UNITED STATES PATENT AND TRADEMARK OFFICE

APPLICATION NO.	FILING DATE	FIRST NAMED INVENTOR	ATTORNEY DOCKET NO.	CONFIRMATION NO.
10/057,619	01/24/2002	Ivan J. Baiges	10017070-1	2301

Office Action Summary	Application No.	Applicant(s)
	10/057,619	BAIGES, IVAN J.
Examiner	Art Unit	
Blaise L Mouttet	2853	MW

DETAILED ACTION

FIG. 10

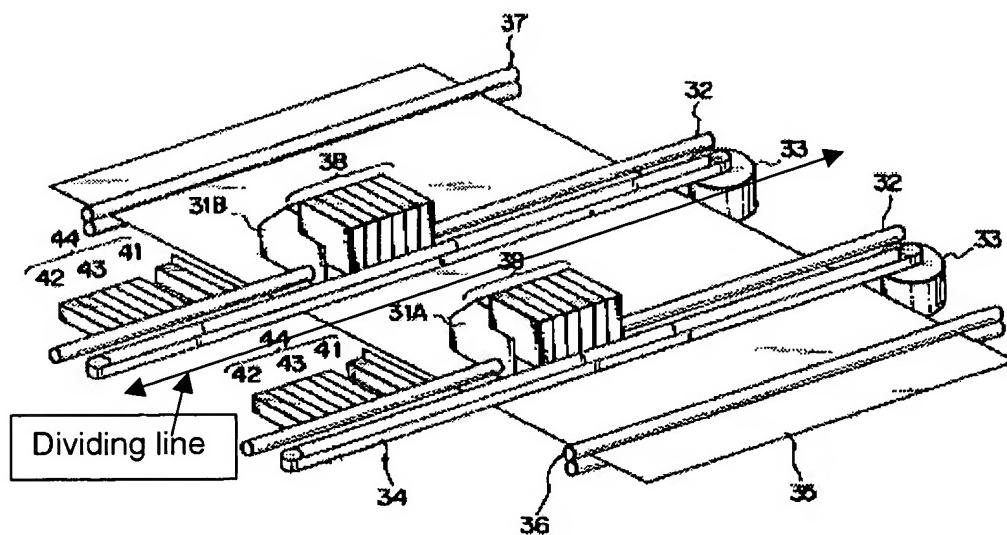
a first marking engine/printhead assembly (31A) for depositing a first marking fluid only on a first portion of a first side of the print media as shown and described in relation to figure 10;

a second marking engine/printhead assembly (31B) for depositing a second marking fluid only on a second portion of a first side of the print media different from the first portion as shown and described in relation to figure 10,

a first mechanism (32-34) coupled to the first marking engine (31A) for moving the first marking engine (31A) back and forth across the print media so that the first marking engine (31A) can deposit the first marking fluid (ink) only on the first portion of the print media as shown and described in relation to figure 10; and

a second mechanism (32-34) coupled to the second marking engine (31B) for moving the second marking engine (31B) back and forth across the print media so that the second marking engine (31B) can deposit the second marking fluid (ink) only on the second portion of the print media as shown and described in relation to figure 10.

Regarding claim 3, the mechanisms are spaced apart as indicated in figure 10.

Regarding claim 4, the mechanisms employ identical structure as shown and described in relation to figure 10.

a drive element (34) coupled between drive motor (33) and the marking engines (31A, 31B) linearly moving the respective engines along the guide rods (32) back and forth across the media as shown and described in relation to figure 10.

Regarding the arrangements of the first and second mechanisms as specified in claims 35-40, the mechanisms are adapted to function as claimed as shown and described in relation to figure 10.

moving the first and second printhead assemblies back and forth across the print media along the first direction while the first printhead assembly deposits ink only on a first portion of a first side of the print media and the second printhead assembly deposits ink only on a second portion of the first side of the print media different from the first portion along the first direction (figure 10, column 20, lines 43-52).

Regarding claim 41, the printhead assemblies are moved back and forth across the print media in a first direction and the printhead assemblies are spaced apart in a direction perpendicular to the first direction as indicated in figure 10 and column 20, lines 43-52.

Regarding claim 43, moving of the printhead assemblies is performed and the assemblies are spaced apart as shown and described in relation to figure 10.

The examiner first notes that as drawn to apparatus claims it is structure rather than function that must differentiate the claims from the prior art (see MPEP 2114, *In re Schreiber*, 44 USPQ2d 1429 (Fed. Cir. 1997)). Nevertheless it is clear from the description and drawings of Yashima et al. that simultaneous printing on spaced apart portions of the recording medium is performed by different printheads scanned by separate carriages (figure 10, column 20, lines 48-52). While at a later time after print medium advancement it is possible that overlap printing MAY be performed this is not seen as a disclosed or necessary feature of the Yashima et al. disclosure and
